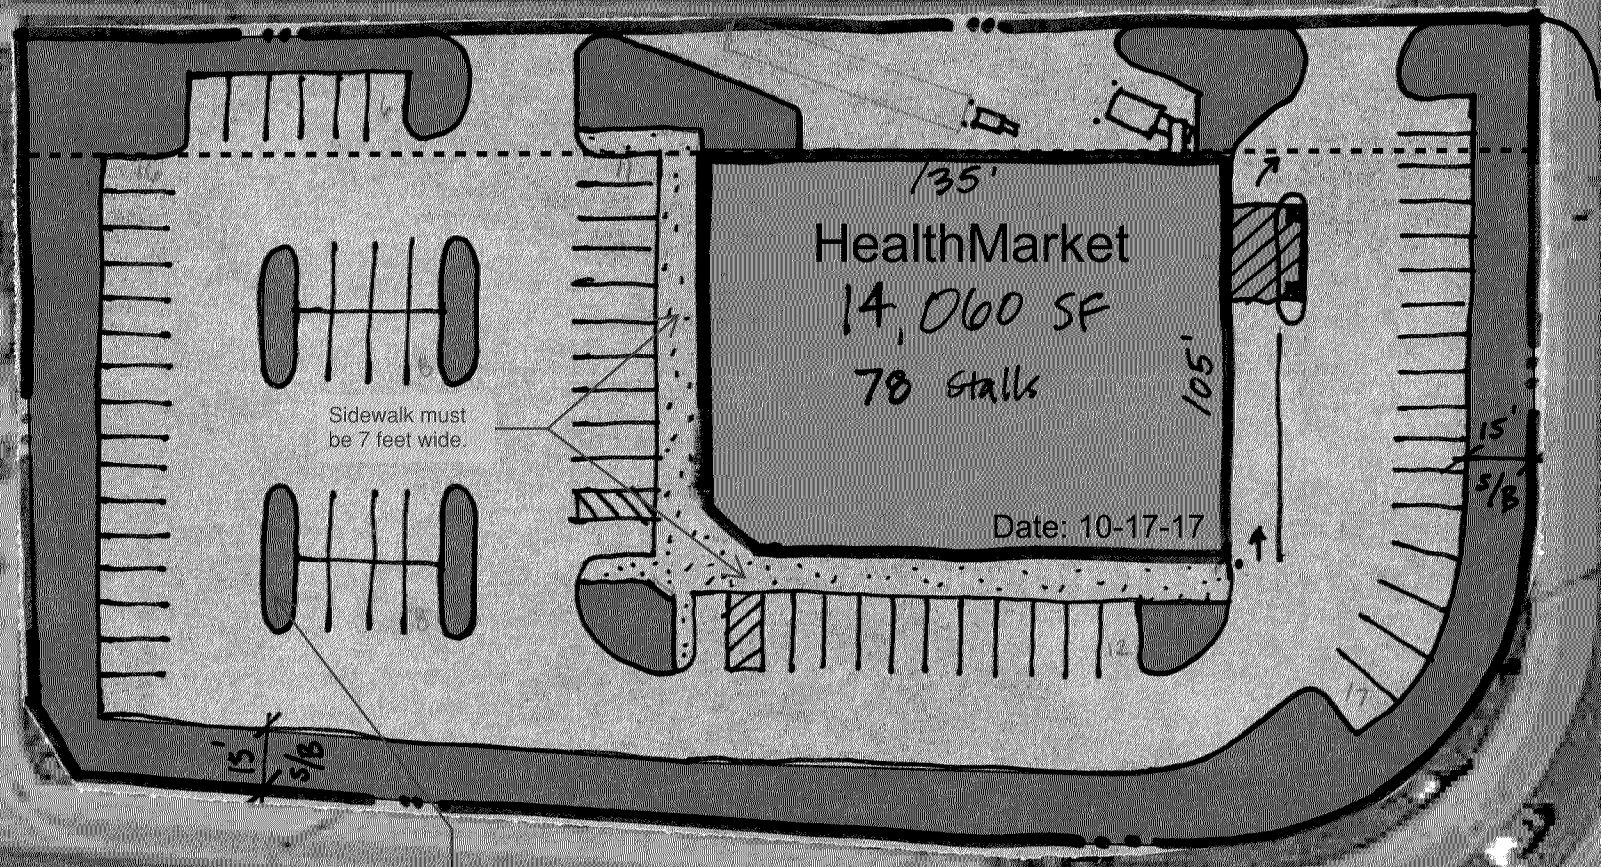
A parking analysis must be completed for REI. If the loss of parking due to the access is below Code, a variance is required or REI could consider rezoning to a Planned Development and seek deviations.

Provide emergency responder communication on the property and in the building per IFC Appendix L

Provide emergency vehicle access around and through the property. Meet the turning radius requirements for BFD Ladder 1 & 3.

Provide hydrants within 150' of any portion of the building and within 50' of the FDC.

RIRO Driveway

Standard Non-Residential Driveway Approach is needed using Bloomington Standard Detail

Provide a connection for existing sidewalk to the facility

All islands must be 8 feet wide and include a tree.

The existing driveway at American Boulevard and proposed driveway on Lyndale should be studied in the traffic study.
